Project Name: Woodsmoke – Rezone & Preliminary

PRELIMINARY DEVELOPMENT PLAN
AND
ZONE CHANGE REQUEST
FOR
WOODSMOKE

REVIEW SHEET SUMMARY

FILE NO. 79-81 DUE DATE 8/16/81
 ACTIVITY Woodsmoke
 PHASE Rezone & Preliminary ACRES _____
 LOCATION W. of 29 Rd., N. of GV Canal, E. of Indian Wash
 PETITIONER John Kilpatrick
 PETITIONER ADDRESS Rt. 1, Box 195 A, Keensburg, CO 80643
 ENGINEER Paragon Engineering, Inc.

OFFICE COPY
#79-81 SCALE 1" = 40'
COURTSHIP INTERVAL 2'
SITE & LANDSCAPING PLAN

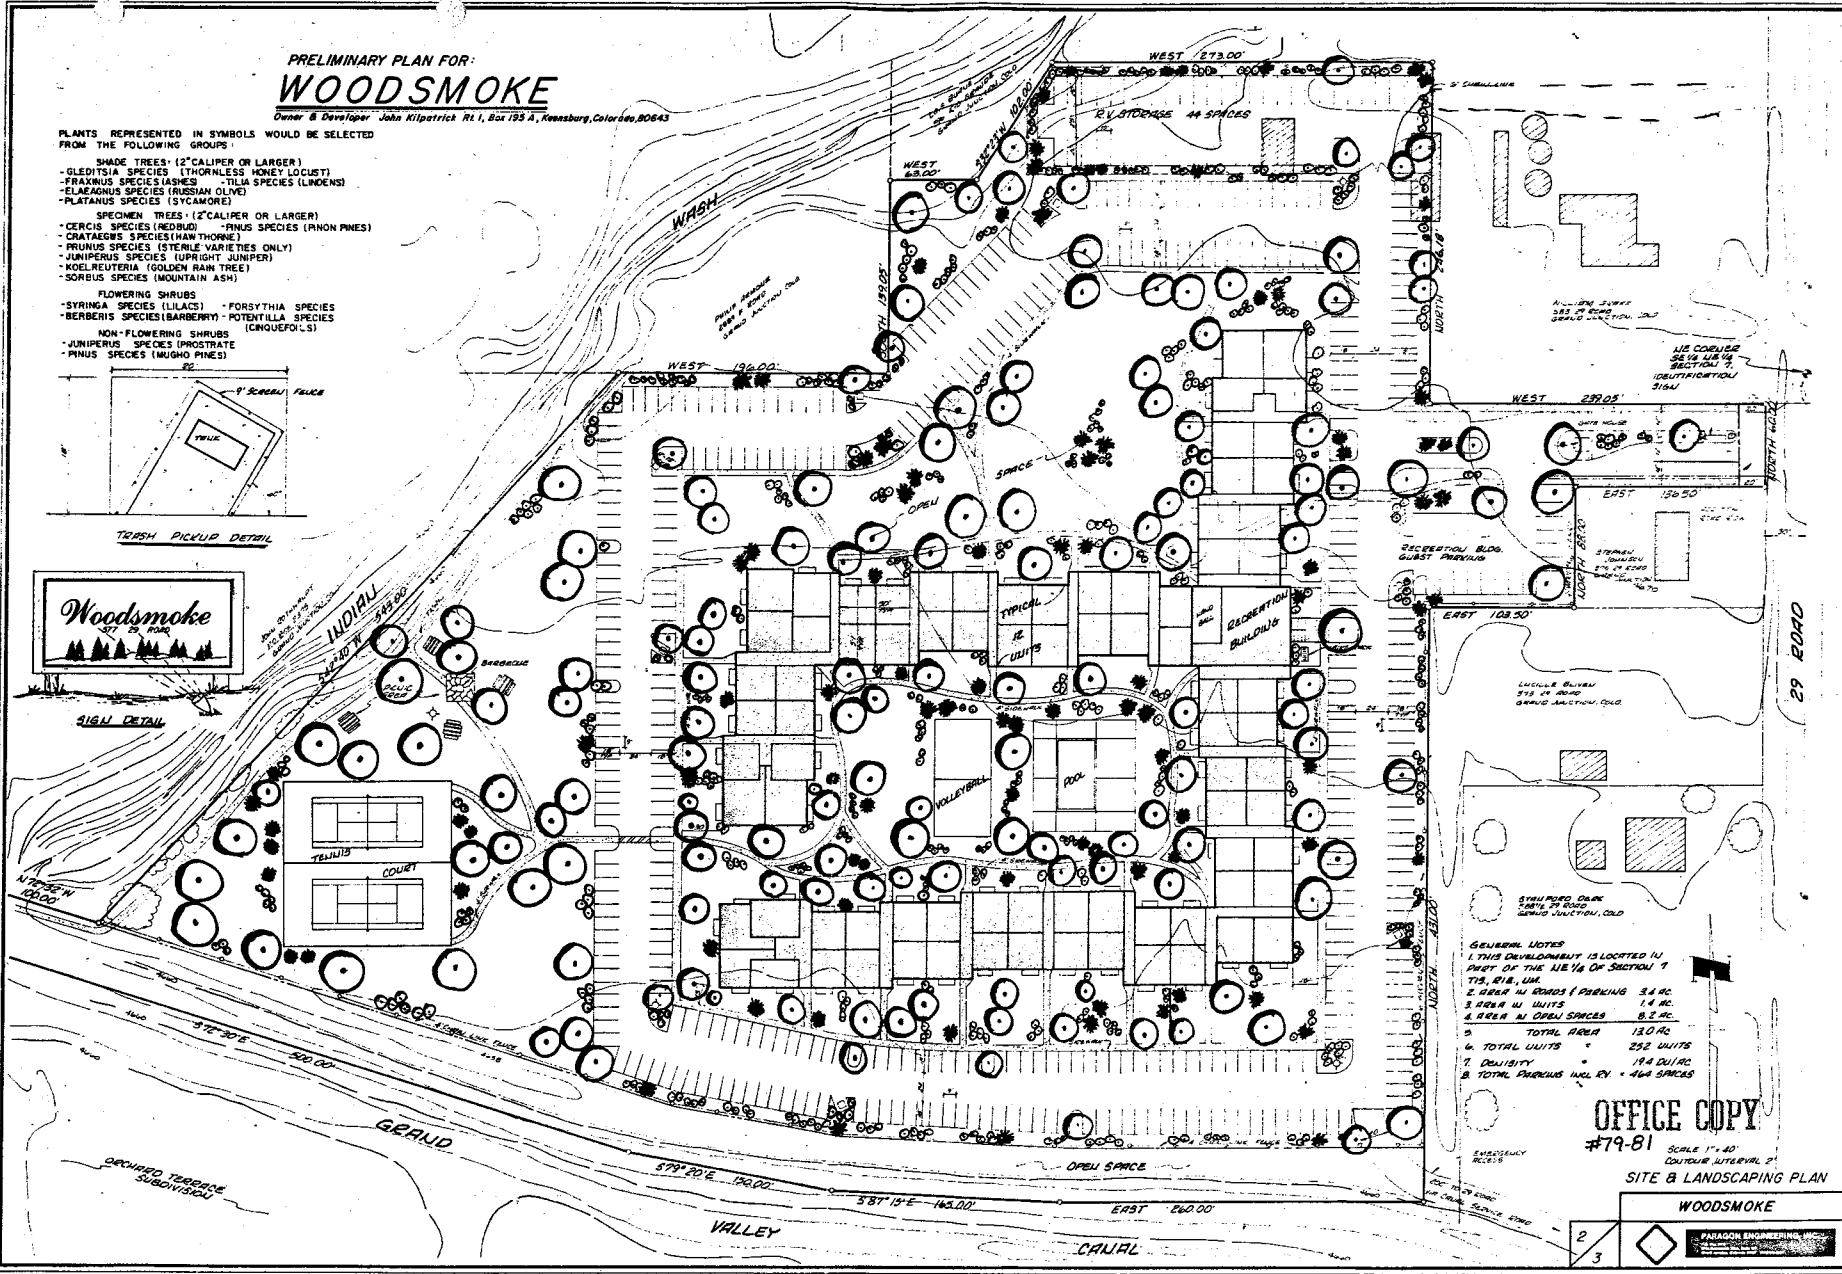
8/13/81	City Parks/Rec.	<p>No comment at this stage. Planting Plan not detailed enough for proper evaluation.</p>
8/14/81	Transportation Engineer	<p>A single access point to serve 252 apartments is <u>not adequate</u>.</p> <p>The use of the Canal Road as "Emergency Access" should be cleared with the Grand Valley Canal Co. is this an all-weather Road? This "Emergency Access" Road does not negate the need for another full access point.</p> <p>The room for maneuvering in the R.V. storage area seems inadequate.</p>

<u>DATE REC.</u>	<u>AGENCY</u>	<u>COMMENTS</u>
	Continued Transportation Engineer	Turning radii at the corners should be checked to see if fire equipment, sanitation trucks, moving vans, etc. can negotiate the turns.

8/14/81	Mountain Bell	No comments.
8/17/81	Staff Comments	<ol style="list-style-type: none"> 1) What is your proposed ground cover? (need detail of what will be where) 2) Will tennis courts be lighted? What about interior courtyard lighting detail? 3) What type of buffering/screening will exist on north side of project? (also west to Indian Wash?) Also screening along ingress/egress? 4) Nice to see bikeracks. 5) Has trash pick-up been coordinated with Bill Reeves? 6) Any Handicap parking proposed? 7) Any proposed alterations of Indian Wash? If so, need floodplain analysis. 8) Lots of pedestrain walkways. 9) Will need Power of Attorney or Improvement Agreement. 10) Need sign detail (Height). 11) Will chain link fence have ingress/egress anywhere? 12) Will the emergency access have crash gates? 13) Need letter of commitment for irrigation rights. 14) Will RV area be designated? 15) As trash pick-up is shown, will this create traffic hazards? 16) Parking regulations not met. Need minimum 18.5' x 9' & 25' aisle width. <p>Project must obtain Building Permit within 1 year of approval or be scheduled for a rehearing.</p>

8/17/81	City Utilities	<p>It would be nice if the interior walkway in the northernmost open space area could be expanded into a service road for access to the sewer manhole by sewer maintenance equipment.</p>

1. Ground cover to be lawn.
2. Tennis courts will be lighted. Walk lights will also be provided.
3. No buffer/screening will be provided to North or along Wash. Landscape screening will be utilized along South side of ingress/egress.
4. Trash pickup to be coordinated with Bill Reeves.
5. Handicap parking will be provided at office/indoor recreation building.
6. No proposed changes to Wash.
7. Petitioner will make physical improvements to 29 Road.

<u>Agency</u>	<u>Response</u>
City Fire Department	Water mains for fire protection will be 8" looped line with one point of connection to an existing 8" water main in 27 Road. Combination walkway/access to interior court yard will be provided. Detailed construction plans will be provided prior to building permit issuance for Fire Department review. Hydrant agreement will be signed.
Floodplain Administrator	100 year flood plain limits indicated on grading/drainage plan. No alternations are planned within the 100 year flood plain.
City Parks and Recreation	Detailed landscaping plan will be submitted for review with final development plan.
Transportation Engineer	An additional access point will be provided to Woodsmoke. This access lies North of the existing dairy building. It should be understood that this access will be used only in the event of blocking of the proposed access point indicated on the submitted preliminary plan. All turning radii are at current minimum for dedicated City neighborhood roads.

INDIAN WASH
 SECTION X-X

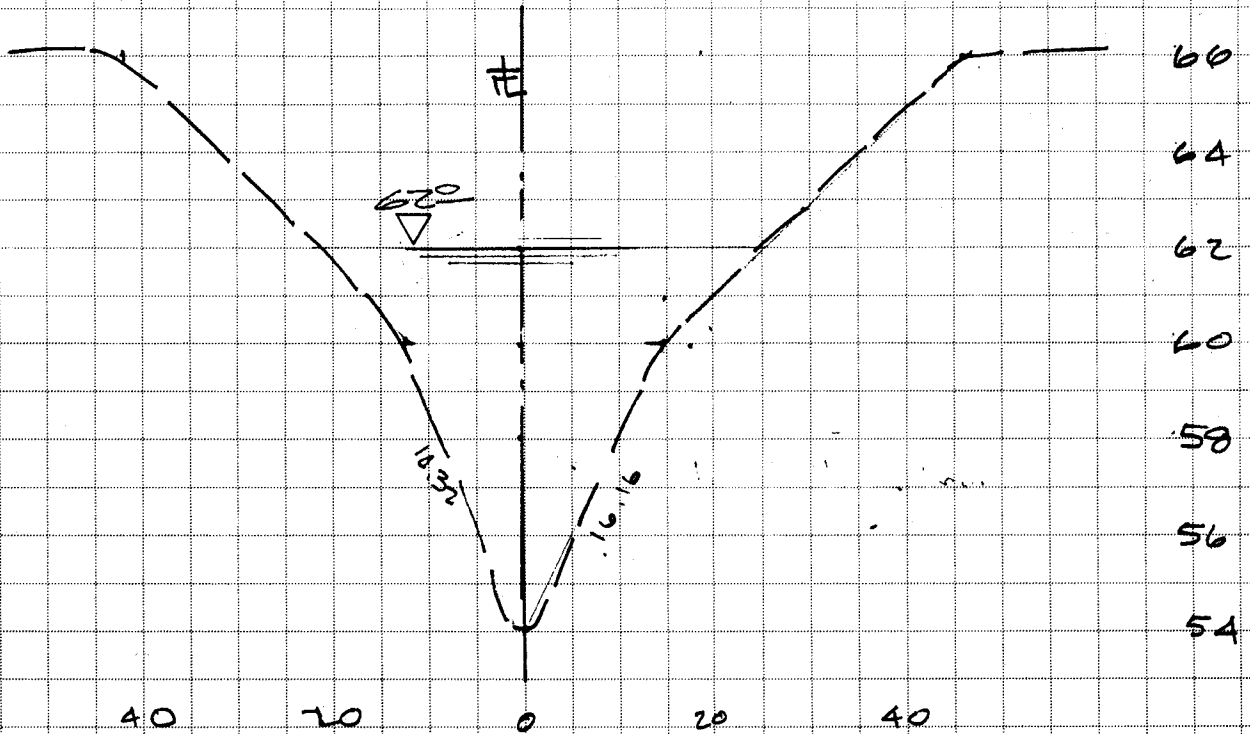
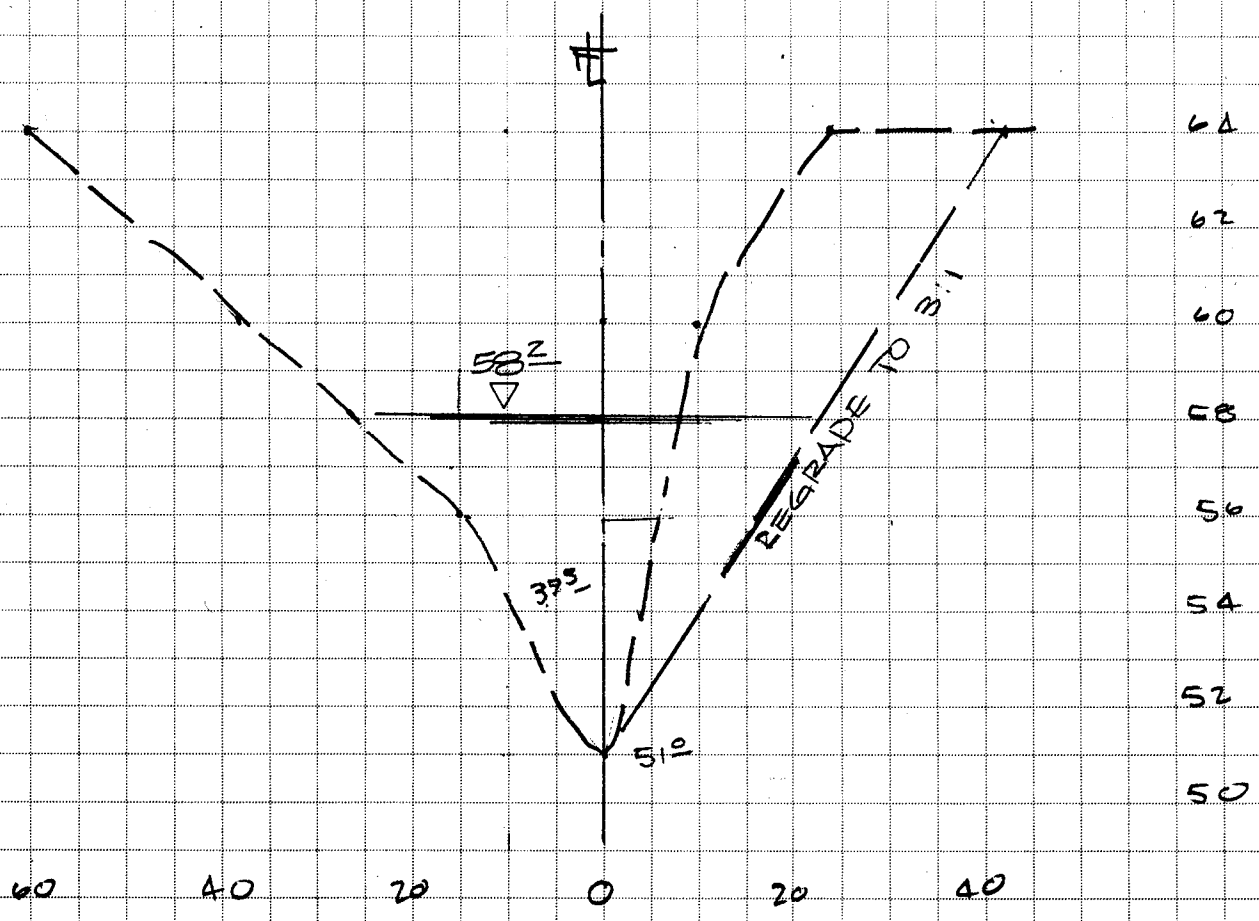
- 10/14/82 Floodplain Admin. The packet states a FP permit will be at the time of construction request. If this is the case, in the analysis of the flood hazard report, it states there will be regarding of the banks and grubbing. As per Sec. 5-8 FP regs of the City of Grand Junction, any modification, alteration or change within the designated 100 year flood plain will require a city FP permit. Before the petitioner attempts to "regrade the channel banks" of the wash, a FP permit will be required, with the adequate analysis of up and downstream effects of this modification, found acceptable to the City. A FP fee will be collected at that time. This could affect the character of that area not shown on the plan, which may be encroaching into the 100 yr. FP. A building permit hold will be placed on this project until that permit has been reviewed and approved.
